**Minutes of the Meeting  
September 17, 1998**

091798.1      Project: **Pacific Place**  
                  Phase: Sign Permit Special Exception (subcommittee: Dubrow, Sundberg, Foley)  
          Previous Review: August 6, 1998  
          Presenters: Matt Griffin, Pine Street Development  
                          Jane Lewis, Pine Street Development  
                          Stanley Morris, Stars Bar & Dining  
                  Time: .5 hr. (hourly)

People's Lodge site plan

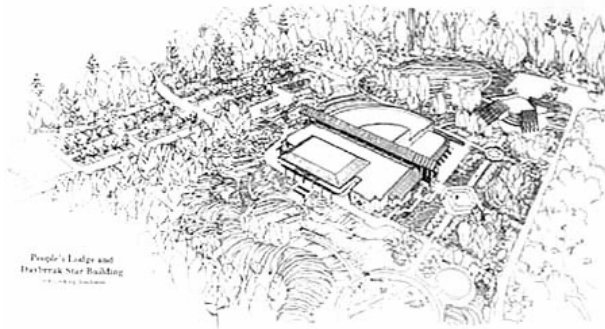
**Swift:** The proposed parking lot appears to be quite extensive. Perhaps a different approach would provide more integration within the park landscape and reduce visual impacts.

**Foley:** I agree with Gail's comments about developing principles. I have concerns about the scale of the proposed parking lot. How long is it along Texas Avenue?

- include a requirement for a set of design principles and guidelines in the DEIS;
- integrate the landscape planning and design phases early in the process with careful attention to spatial character and sequential experience;
- develop a Transportation Master Plan that utilizes existing parking areas at the perimeter of the park for peak events and significantly reduces the proposed parking area.

Proposed configuration

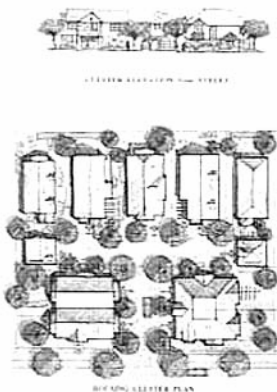
**Swift:** It appears that the new north entrance will take the bulk of traffic out via Sylvan Way rather than through the adjacent neighborhoods. Have you thought about providing additional access at the south end, to connect back into the city street grid?

**Swift:** This seems like a very appropriate plan for the site. The vacation is more like a street shift to take advantage of the site opportunities, than a physical vacation. I have a minor concern about the south connection in relationship to the street grid. Is there any opportunity for vehicular access at the south end? What are the issues associated with access to the south?

**Foley:** The plan seems to lack open space. I suggest exploring small open space opportunities for child play among the duplex units.

- **pursue a vehicular entrance at the south end of the development;**
- **provide a strong pedestrian connection at the south end of the development if a vehicular entrance is not possible;**
- **endeavor to develop opportunities for open space within the development;**
- **continue to develop the multi-family housing units with increased variety and individual character.**
